PROPOSED WAREHOUSE (EXCLUDING DANGEROUS GOODS GODOWN) WITH ANCILLARY FACILITIES FOR A PERIOD OF 5 YEARS

Appendix III - Response to the Head of the Geotechnical Engineering Office, Civil Engineering and Department (H(GEO), CEDD) and a Revised Geotechnical Planning Review Report (GPRR)

Geotechnical Planning Review Report

FIGURE 7

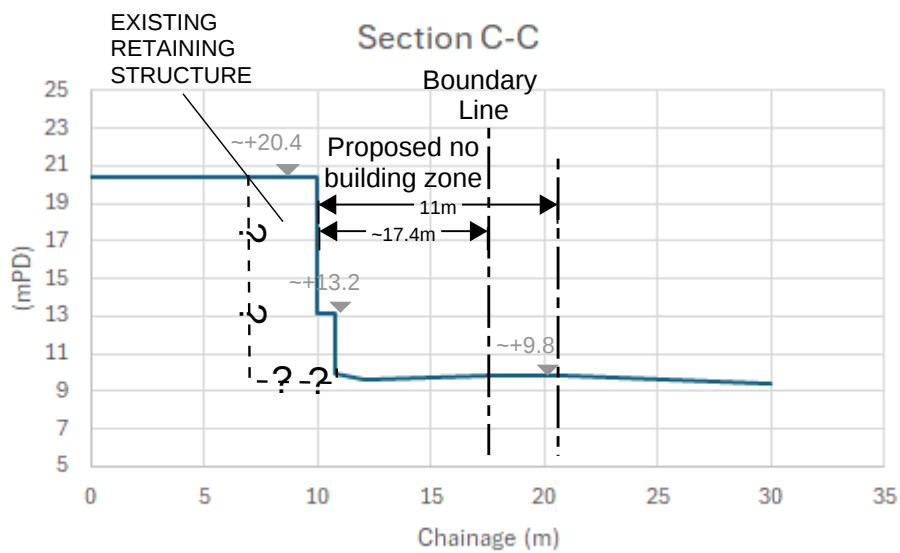
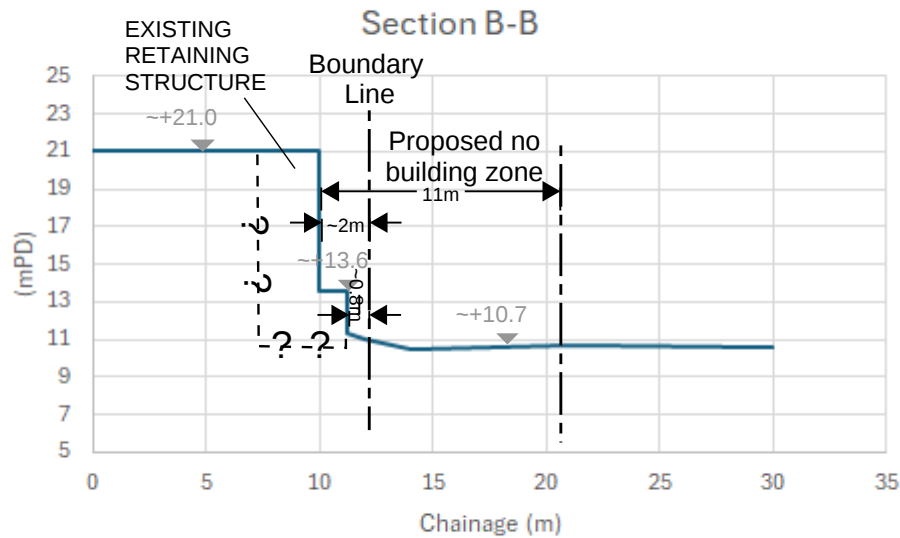
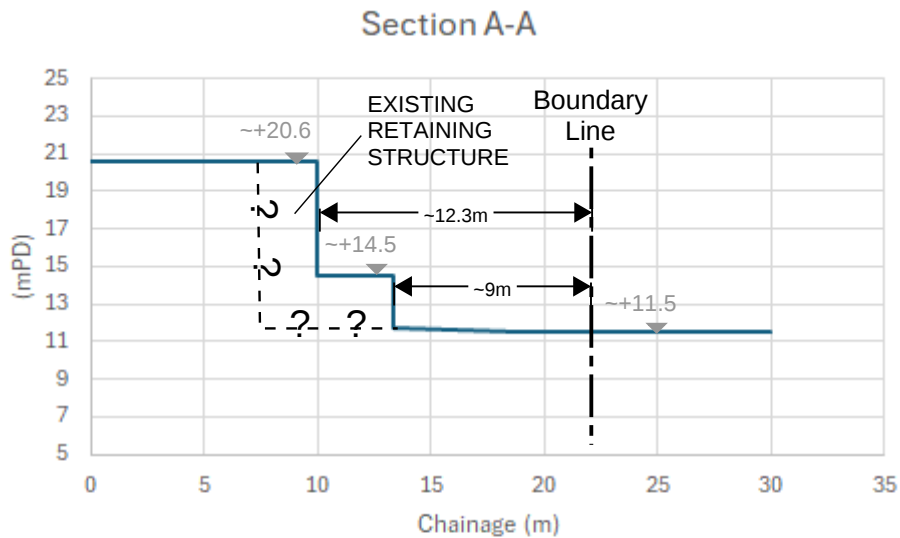
(3)	The presence of any unauthorised retaining structures might affect or be affected by the proposed development in the application site. As shown in the topographic survey plan in the Geotechnical Planning Review Report (GPRR), it appears that an approximate 10m vertical level difference (from +10.0 mPD to 20.6 mPD) could be identified in the western side of the application site. Hence, the applicant should provide adequate cross sections to showcase the profile of these unauthorised retaining structures (which were probably formed under the suspected unauthorised works), the location and their geometrical relationship with the subject application site. Given the above, the applicant should incorporate, in the next revision of the GPRR, the geotechnical review of these retaining structures, and the	It is noted that the existing retaining structure is outside the proposed development. There is no public information regarding the design and construction of existing retaining structures. It is proposed a no building area of 11m (which is height of the existing structure) from the toe of the existing structure. Please see sections in Figure 7 and no building area in Appendix B for your perusal (enclosed).

- 5.1.1 According to the topographic survey and site photos, the existing feature **3NW-C/F 22** within the Application Site is no longer exists and the level difference is retained by a retaining structure under other development. Cross sections showing the relocation of existing retaining structure and the site boundary are shown in **Figure 7** for reference. It is noted that the retaining structure is unauthorized and there is no information regarding its design and construction. The retaining structure is about 10.6m height, it is proposed a no building zone from 11m of external face of existing retaining structure. The proposed no building zone is also shown in **Figure 7**.
